UNITED STATES PATENT AND TRADEMARK OFFICE

Office Action Summary	Application No.	Applicant(s)	
	10/726,642	RINKE ET AL.	
	Examiner	Art Unit	
	Rashmi K. Sharma	3651

Application No. 10/726,642 Confirmation No. 6203
Applicant: Andreas RINKE et al. Attorney Docket No. P24369
Title: MULTIFUNCTIONAL CONVEYING DRUM
Responsive to Official Communication dated: July 14, 2005
REPLACEMENT SHEET

FIG. 2

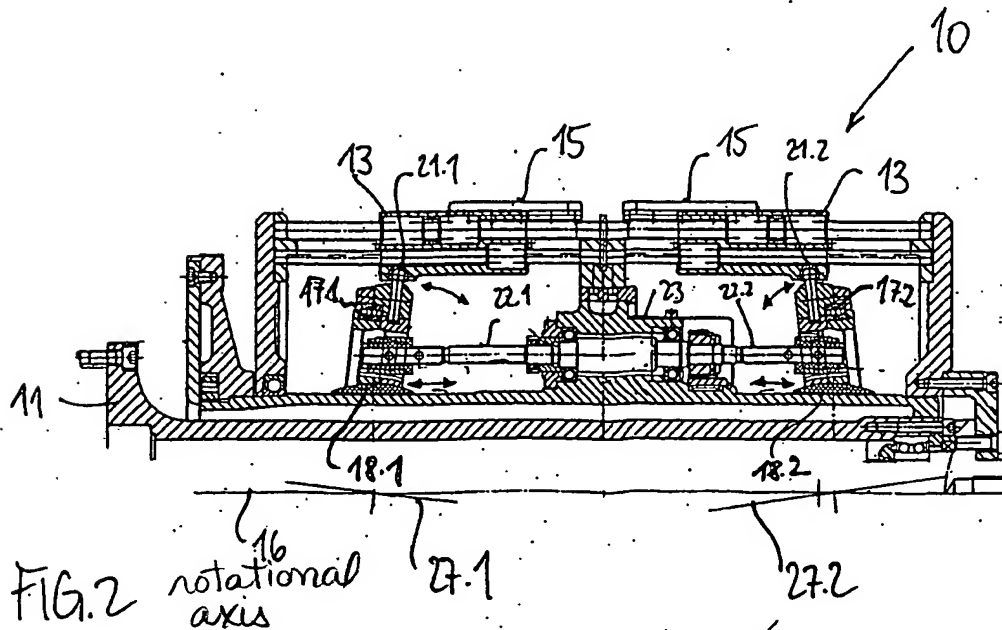
Regarding the drawing objections and the 112 second paragraph rejections, Applicant filed replacement sheets for Figures 2, 3 and 5, however it is still unclear as to how the wobble plates rotate about horizontal rotational axes 27.1 and 27.2. It appears as though the wobble plates are rotating about vertical axes, as indicated by the double arrows depicted in Figures 1 and 2. It is still unclear as to what structure rotates about 27.1 and 27.2 and exactly how the angle between axes 27.1 and 27.2 is changeable relative to axis 16. Further clarification is required.

Not Approved - RS

The replacement sheets of drawings attached as part of the Appendix includes changes to Figures 2, 3, and 5. These sheets, which include Figures 1 – 5, replace the original sheet including Figures 1 – 5. In Figures 2, 3, and 5, reference planes 27.1, 27.2 have been added for wobble plates 17.1, 17.2, respectively.
